**PLANNED UNIT DEVELOPMENT
& SUBDIVISION STAFF REPORT****Date: November 16, 2017****DEVELOPMENT NAME**

PAM Mid Town Subdivision

Subdivision approval to create one legal lot of record and
Planned Unit Development approval to allow a new off-site
parking lot to accommodate an existing medical clinic.

SITE PLAN

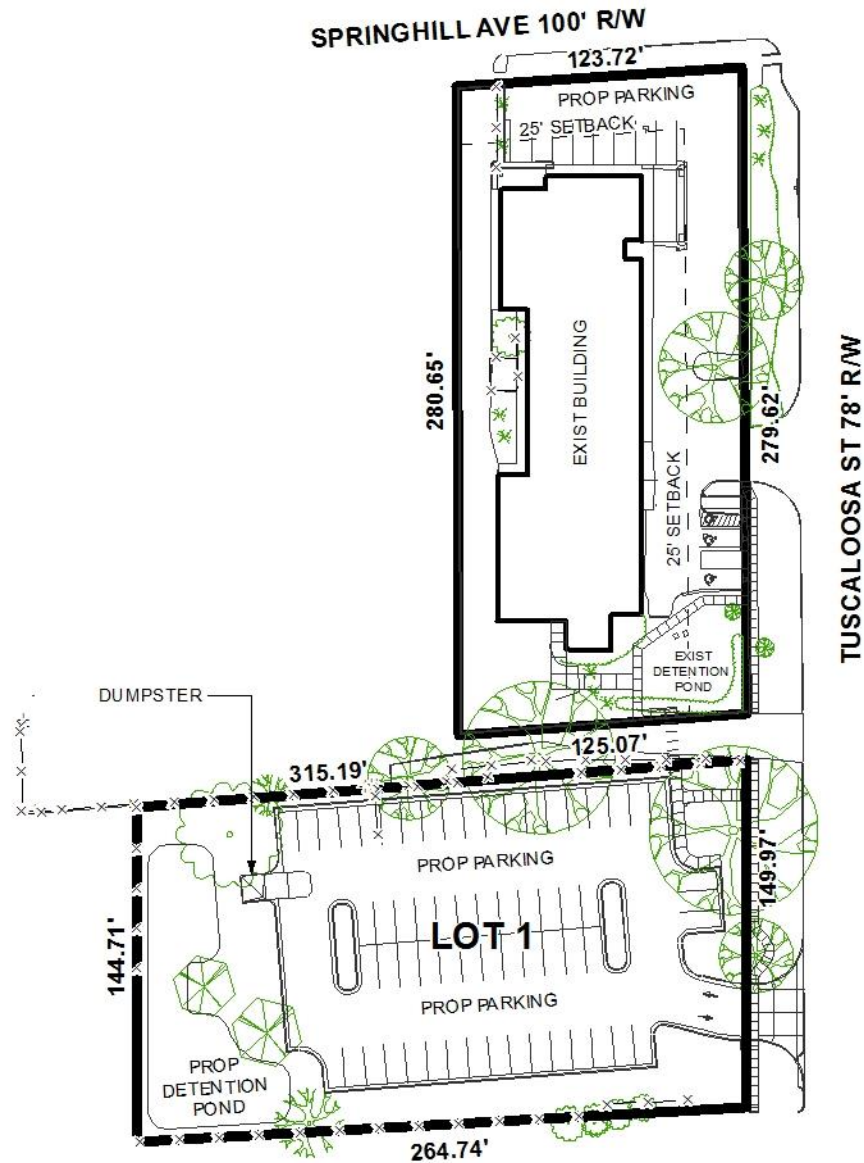
The proposed site plan will negatively impact access to the traffic signal that aligns with Stanton Road at Spring Hill Avenue. If this proposed development removes the asphalt on their property within the drive aisle, the traffic signal for that approach will have to be removed. The developer must coordinate with Traffic Engineering at time of construction for the City to remove the necessary equipment. The 2005 subdivision application for this site limited the corner parcel to the one shared driveway with the adjacent development. As a means of access management, the concrete pavement in the right-of-way of Spring Hill Avenue between the sidewalk and the curb should be removed and landscaped to prevent its use as a driveway. Also, the concrete apron for the drive aisle that is to be modified should be removed and grassed adjacent to the owner's property to further prevent its use as a two-way driveway. In conjunction with the signal removal, the City will designate the driveway portion remaining on the adjacent property as an entrance only driveway. New on-site parking, including ADA handicap spaces, shall meet the minimum standards as defined in Section 64-6 of the City's Zoning Ordinance.

Revised for the November 16th meeting: No additional information, therefore previous comments stand. If proposed plan to landscape to the west of the existing building is abandoned and remains unchanged, changes to the traffic signal will not be required. Removal of the concrete in the right of way of Spring Hill Avenue (between sidewalk and curb) is still a requirement to maintain the condition of the previous approval only allowing the one access point to Spring Hill Avenue.

Regarding the PUD request, the applicant proposes to expand the footprint of the existing medical clinic by enclosing an entryway and former drive-thru porte-cochère. Additionally, the site plan illustrates curbing where the original Administrative PUD site shares access and parking with the adjacent site, thus eliminating reciprocity. As such, additional parking is necessary to accommodate off-street parking requirements for a medical clinic in a B-1, Buffer Business District. A 20' wide portion of the adjacent lot inhibits cross access between the original PUD site and a neighboring lot; therefore, the applicant also proposes to develop an off-site parking lot to satisfy these requirements.

The site plan illustrates 11 on-site parking spaces and 62 off-site parking spaces which, when combined, meet the minimum off-street parking requirements regarding number of parking spaces, and stall length and width. Three on-site parking spaces are designated as van accessible and also meet dimensional requirements.

Curbing is illustrated where vehicles could extend beyond existing and proposed parking facilities.

Adequate 24' two-way aisle access and a 24' wide driveway providing access to and from Tuscaloosa Street are illustrated for the proposed parking lot. It should be noted however, that similar aisle configuration on the original PUD property is, at times, reduced by one (1) to seven (7) feet. While access and maneuvering may not meet current requirements, the site was previously expanded in compliance with the approved Administrative PUD.

A note has been placed on the site plan iterating compliance with parking lot lighting requirements per Sections 64-4.A.2. and 64-6.A.3.c. of the Zoning Ordinance, but a photometric plan showing compliance with Section 64-6.A.8. will nevertheless be required prior to the approval of any land disturbing or construction activities.

A proposed sidewalk is illustrated on the site plan along Tuscaloosa Street where the proposed lot has frontage; and existing sidewalks along both streets to which the original PUD site has frontage are also illustrated. Also, a pedestrian safety walkway is proposed across 20' of the

While landscape area appears to meet the minimum applicable requirements, Staff cannot determine compliance with the tree requirements. Tree credit data is not clearly identified and it appears that several off-site trees are being included for credit. As such, revision of the Tree and Landscape plan to adequately identify the amount and types of trees on site will be required prior to the approval of any land disturbing or construction activities.

It should also be noted that any changes to the site plan as a result of comments from Traffic Engineering will need to be illustrated on a revised site plan.

A dumpster pad is depicted on the site plan along with a note stating compliance with Section 64-4.D.9. of the Zoning Ordinance regarding enclosure and sanitary sewer connection requirements. This information should be retained on any revised site plan; or, if necessary, a note stating curbside pickup will be utilized instead may suffice.

Finally, the site is adjacent to several R-1, Single-Family Residential properties, thereby requiring a residential buffer in compliance with Section 64-4.D.1. of the Zoning Ordinance. A 6' wooden privacy fence is illustrated on the site plan where the site abuts residential property and is sufficient to comply with these buffer requirements, but the applicant should note that a separate building permit will be required for any fence(s) constructed on the property.

- 1) provision of a photometric plan in compliance with Section 64-6.A.8. of the Zoning Ordinance;
- 2) provision of Tree and Landscaping plan in compliance with Section 64-4.E.3. of the Zoning Ordinance;

- 4) compliance with Traffic Engineering comments: *(The proposed site plan will negatively impact access to the traffic signal that aligns with Stanton Road at Spring Hill Avenue. If this proposed development removes the asphalt on their property within the drive aisle, the traffic signal for that approach will have to be removed. The developer must coordinate with Traffic Engineering at time of construction for the City to remove the necessary equipment. The 2005 subdivision application for this site limited the corner parcel to the one shared driveway with the adjacent development. As a means of access management, the concrete pavement in the right-of-way of Spring Hill Avenue between the sidewalk and the curb should be removed and landscaped to prevent its use as a driveway. Also, the concrete apron for the drive aisle that is to be modified should be removed and grassed adjacent to the owner's property to further prevent its use as a two-way driveway. In conjunction with the signal removal, the City will designate the driveway portion remaining on the adjacent property as an entrance only driveway. New on-site parking, including ADA handicap spaces, shall meet the minimum standards as defined in Section 64-6 of the City's Zoning Ordinance.);*

DETAIL SITE PLAN

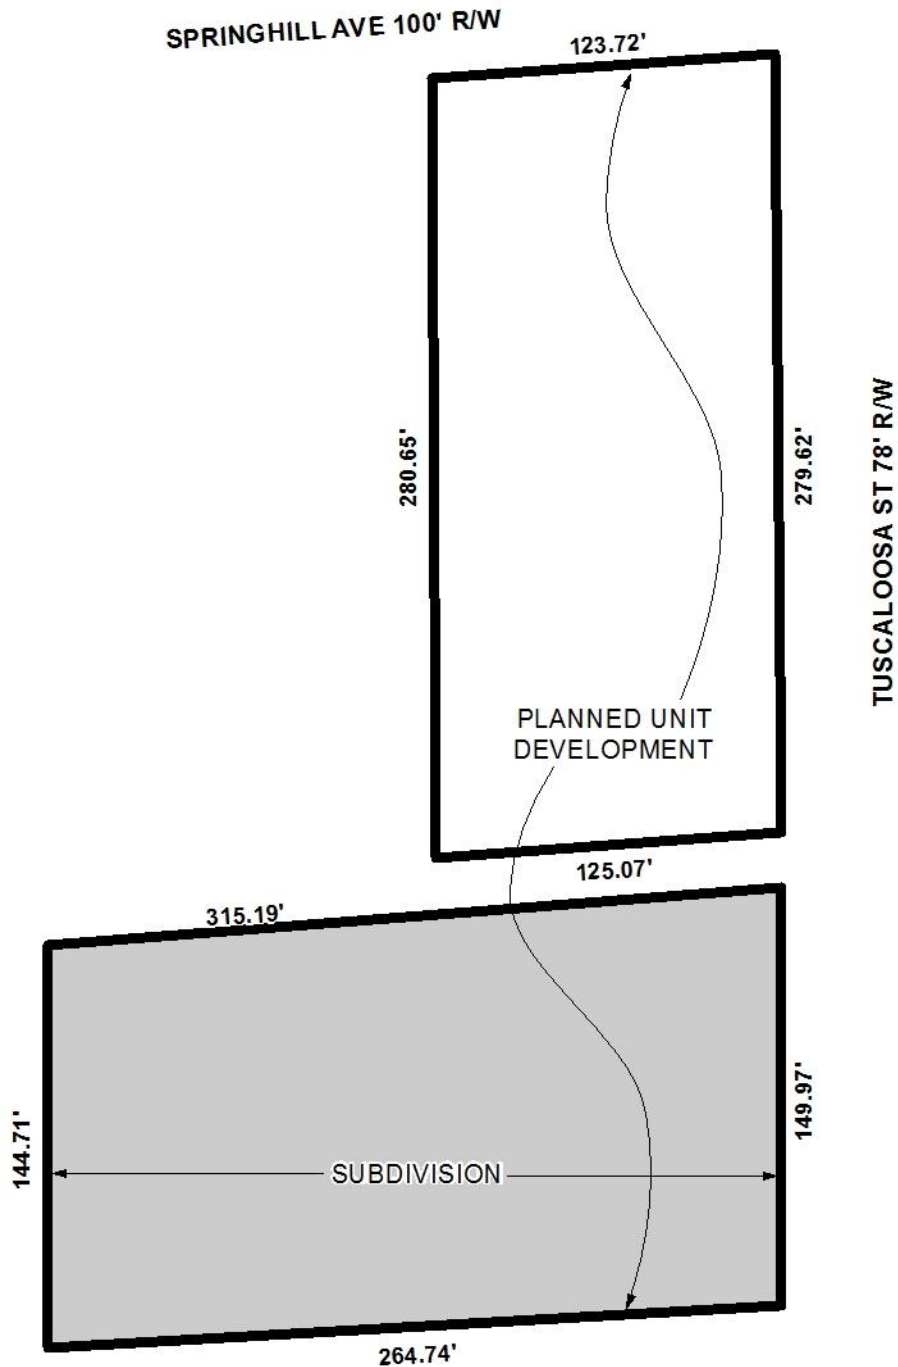
The proposed lot has frontage on Tuscaloosa Street, a minor street with curb and gutter requiring a 50' right-of-way width. The preliminary plat illustrates a 78' right-of-way width at this location; therefore, no additional dedication should be required.

The 25' minimum building setback is illustrated on the preliminary plat and should also be retained on the Final Plat, if approved.

With regards to access management, a note should be placed on the Final Plat, if approved, stating the lot is limited to one curb cut to Tuscaloosa Street, with any changes to its size, location or design to be approved by Traffic Engineering and conform to AASHTO standards.

A house and structural remains are illustrated on the preliminary plat; therefore, it should be noted that demolition permits will be required to remove the existing house prior to the approval of any other construction or land disturbance requests.

- 1) retention of the lot's sizes in both square feet and acres on the Final Plat, or, provision of a table on the Final Plat providing the same information;
- 2) retention of the 25' minimum building setback line on the Final Plat;

- 3) placement of a note on the Final Plat stating the lot is limited to one curb cut to Tuscaloosa Street, with any changes to its size, location or design to be approved by Traffic Engineering and conform to AASHTO standards;
